August 1, 2022

Re: Terramor Responses to NPV July 11, 2022 Memo Comments

The following contains the comments of Nelson Pope Voorhis in their July 11, 2022 Memorandum to you and Terramor's responses to those comments.

Preliminary Construction Schedule (7/29/22)

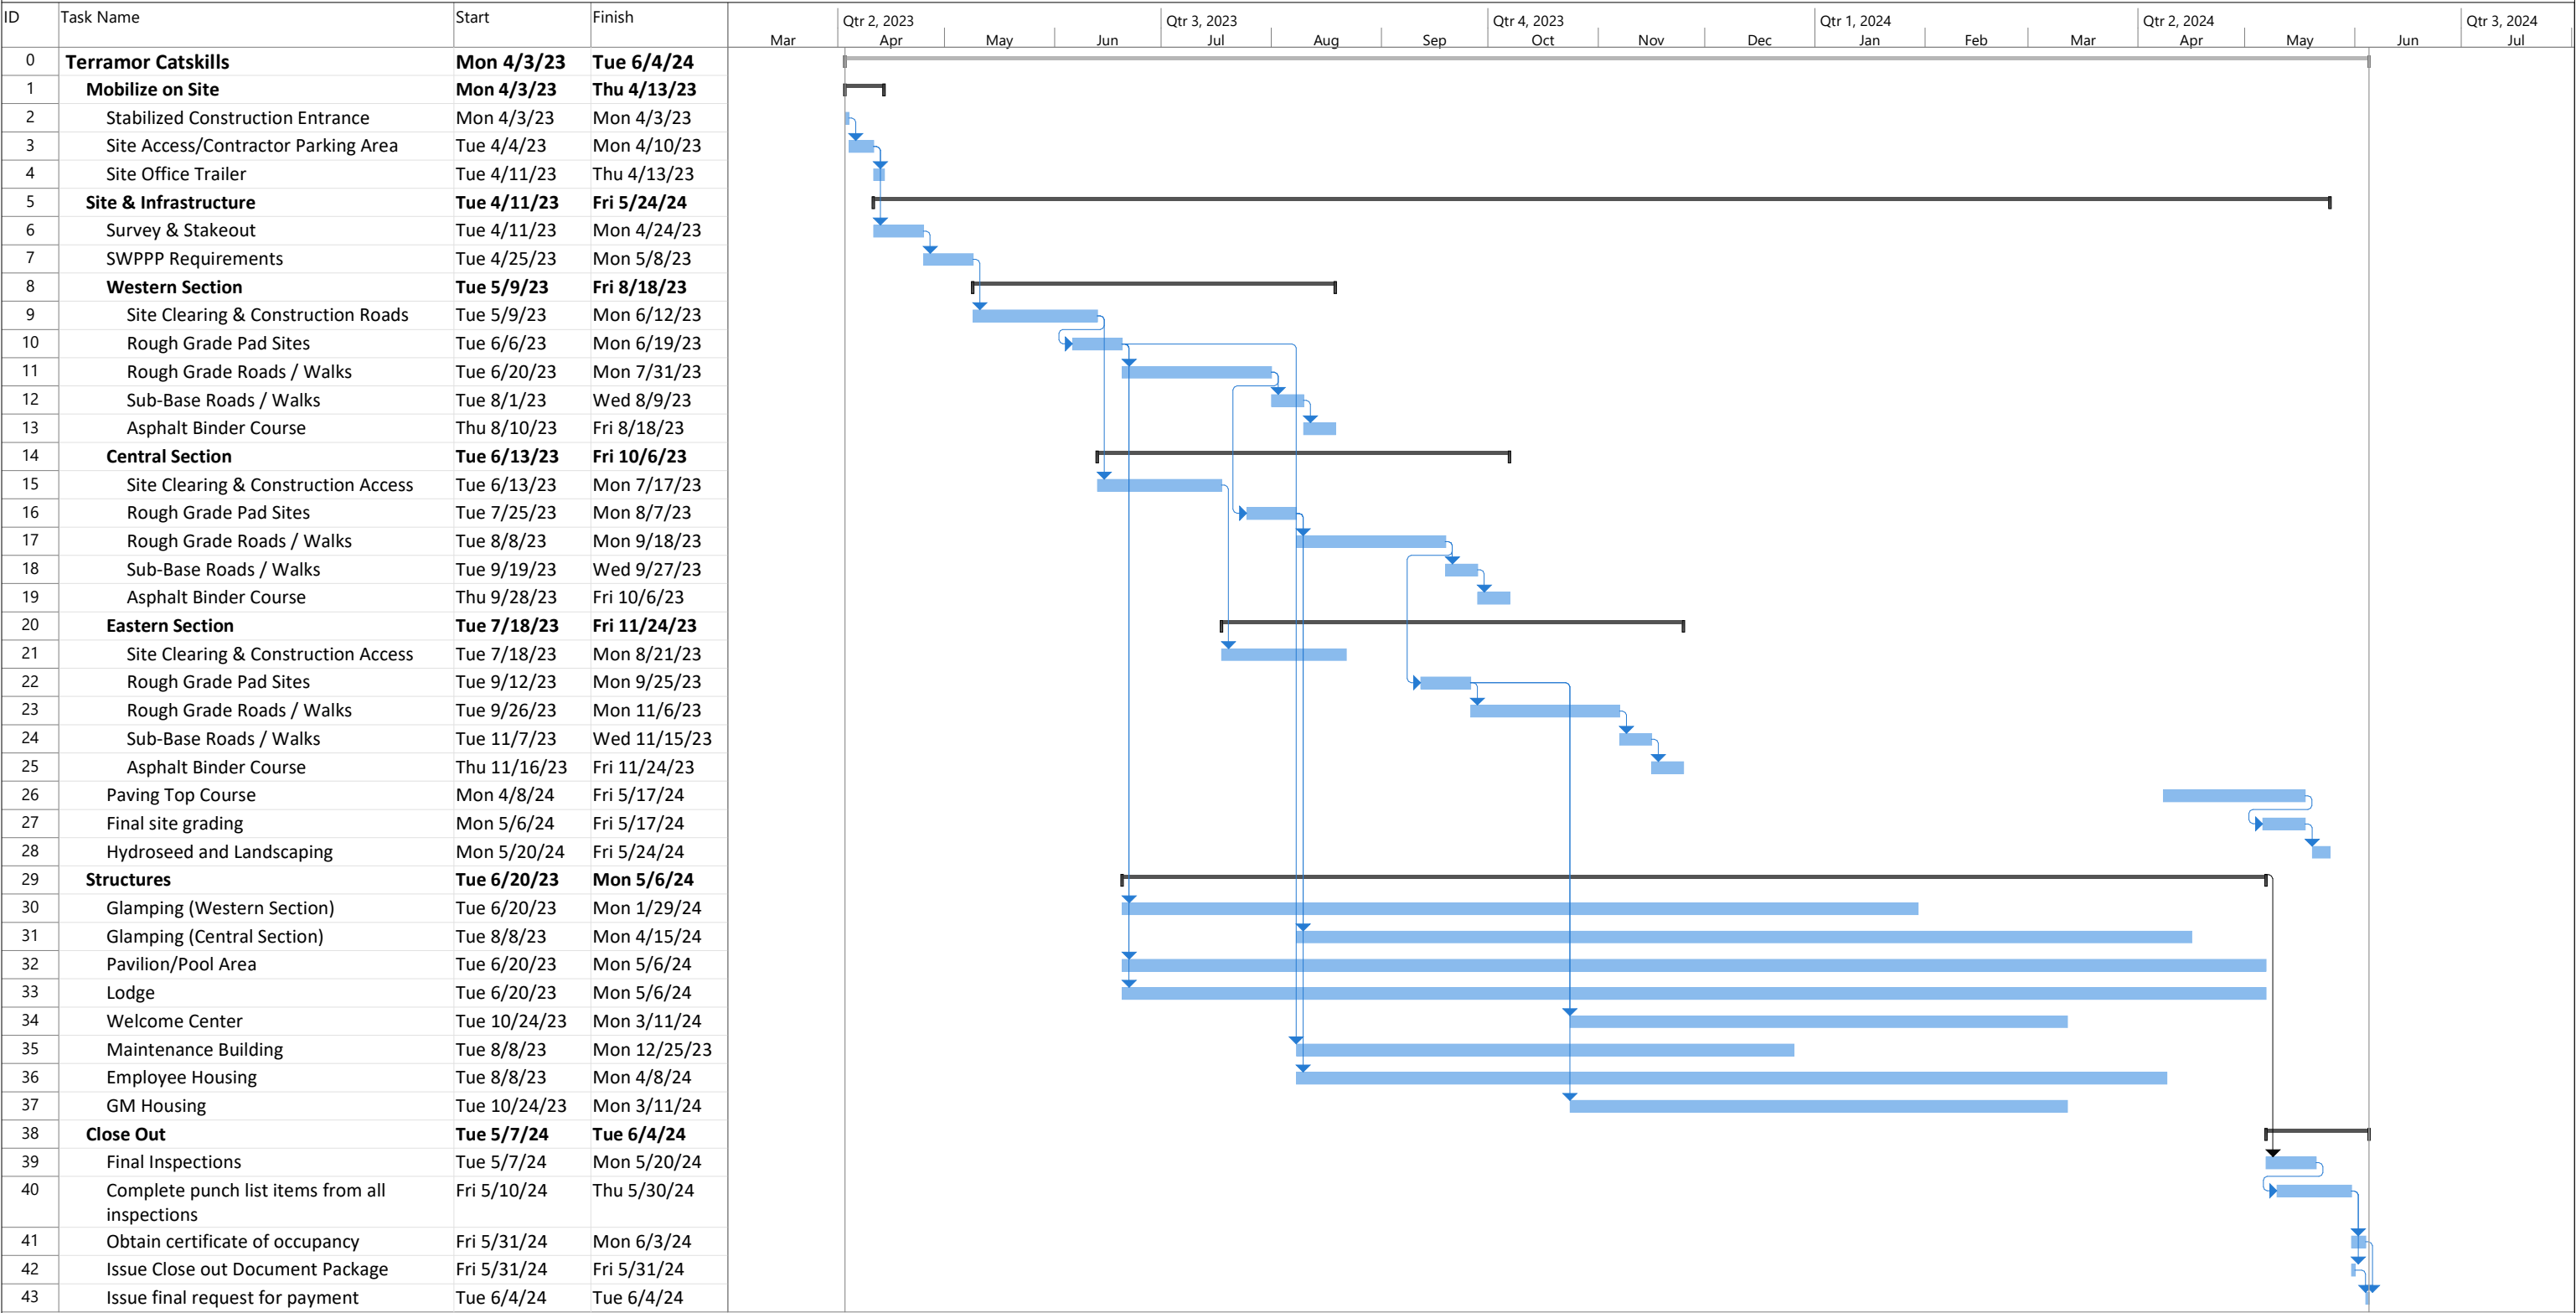
- c. D.1.e- We note that the proposed project will be conducted over the course of a 14-month period. Construction phasing or sequencing should be discussed.

Response: Attachment 8 contains a Preliminary Construction Schedule, including project sequencing. Site work would proceed from the western portion to the central portion and then to the eastern portion, and this would be followed by
